1964 Corvette: Engineering Service Letter: Muncie Four Speed Transmission Design Change

ENGINEERING SERVICE LETTER

SUBJECT: MUNCIE FOUR SPEED TRANSMISSION - 1964 DESIGN
CHANGE AFFECTING PAST MODELS SERVICE REPLACEMENT
AND A FIELD FIX IF REQUIRED

DATE 8-20-63
SECTION 7
MODEL RPO M20 800-
1200-1600-1800 & RPO
M21-1200-1600-1800-1963

FIRST DESIGN

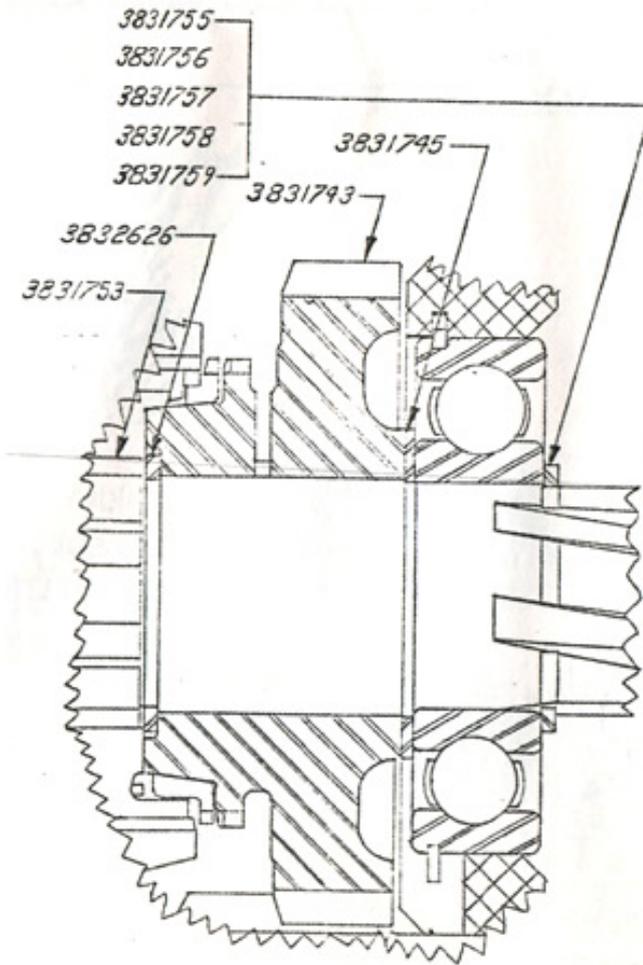
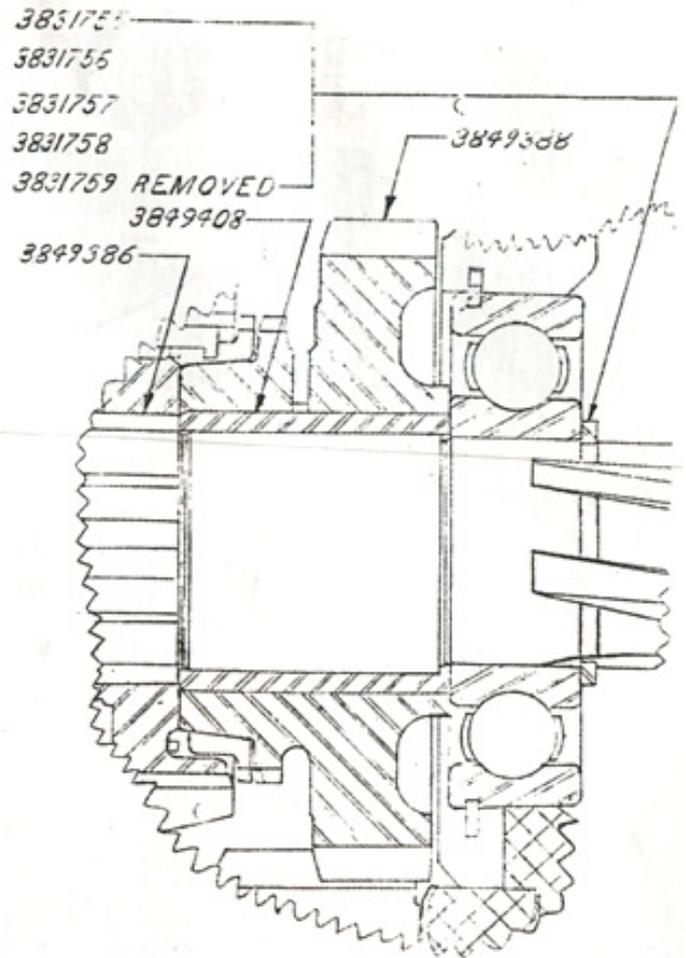
A design change is being introduced for start of production 1964 on subject transmission which includes a new transmission mainshaft, first speed gear, and first speed gear sleeve. The new parts are not interchangeable as details for service replacement on past models. The reasons for the changes are to provide positive first speed gear end clearance, and also to eliminate the possibility of seizure between the inside diameter of the first speed gear and the matching mainshaft outside diameter by use of a new sleeve. The seizure has been reported from the field in several instances at relatively low mileage, and the new parts indicated above are to be used for past model service replacement if this type of transmission failure is noted.

For a comparison between the new and old design in the transmission area affected see attached sketch. Old parts indicated by an asterisk (*) are no longer required as part of revised design.

<u>New Parts</u>	<u>Old Parts</u>	<u>Name</u>	<u>Production Disposition</u>
3849386	3831753	Shaft - Trans. Main	Cancelled & Repl. by 3849386
3849388	3831743	Gear - First Speed	Cancelled & Repl. by 3849388
3849408	-----	Sleeve - First Speed Gear	New
-----	*3831745	Washer - 1st Speed Gear Thrust	Cancelled & Not Replaced
-----	*3831759	Ring - Trans. Main Shaft Rear Brg. Retainer	Cancelled & Not Replaced
-----	*3832626	Ring - Trans. 1st & 2nd Synchronizer Retaining	Cancelled & Not Replaced

From the viewpoint of excessive cost to the customer, if the combination of new parts was used for all past model service replacement, it was decided to maintain old stock.
